Exploring future production scenarios for the Italian offshore wind power
by

D. Medici, A. Tonna & A. Segalini

Comments to Reviewer #1:
(the text of the reviewer is in italic)

Comments to Reviewer #2:
(the text of the reviewer is in italic)

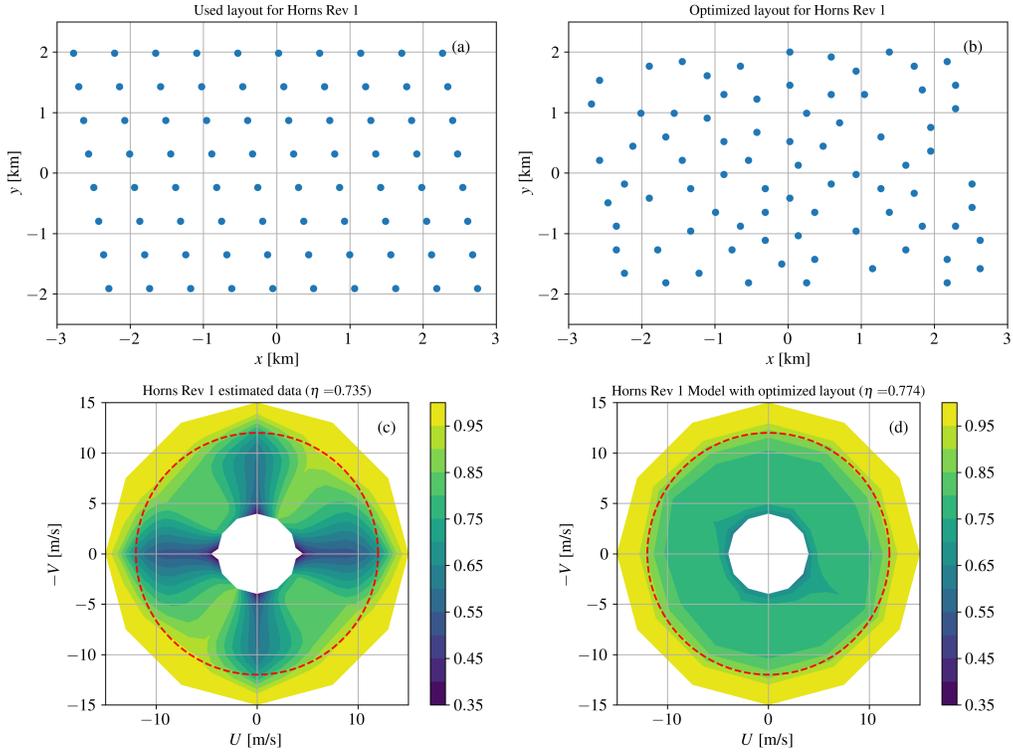
Your results for Lillgrund, actually, confirm my statement because Lillgrund is the worst performing wind farm in the world, with wake losses of the order of 60%, due to the tight spacing ($4.3D \times 3.2D$). Also, Lillgrund was designed originally for much smaller turbines and only at the very last minute they decided to install the Siemens 2.3 MW instead, which had just become available in the market. They were aware that the 2.3 MW turbines would have high wake losses (because of the larger diameter), but they were willing to accept it because the total output was going to be higher than the original anyway. So, the very fact that your algorithm gives you a layout at Lillgrund that performs similarly to the actual layout at Lillgrund means that your algorithm is indeed bad and produces underperforming layouts.

Not true. The prevailing wind direction is the most important

parameter to build an optimal layout.

However, by recognising the concern of the Reviewer about Lillgrund, we have performed a similar analysis on Horns Rev 1. There the intra-turbine spacing is 7 diameters and the farm should be better performing. Figure 1 shows the comparison between the current layout and the approximated one obtained from the geometric optimization. The comparison is qualitatively similar to what observed in the Lillgrund case: the wind directions deeps are removed since no turbine alignments are present in the optimized layout, the average array efficiency is similar to what obtained for the installed layout (actually better since the deeps are removed, but this is also to be weighted by the wind rose as the Reviewer pointed out). This figure will not be included in the manuscript because we deem the Horns Rev 1 estimate analysis potentially influenced by the used wake model (the Jensen model here), and therefore of lower quality than the Lillgrund analysis where SCADA data were used.

Correct. The comment that the Reviewer was referring to was included in the previous answer and only relative to the array efficiency of the Lillgrund farm with the layout estimated with the genetic algorithm. There the wind direction does not play a significant role compared to the velocity magnitude. The same consideration could be extended for the Horns Rev 1 analysis shown in figure 1.
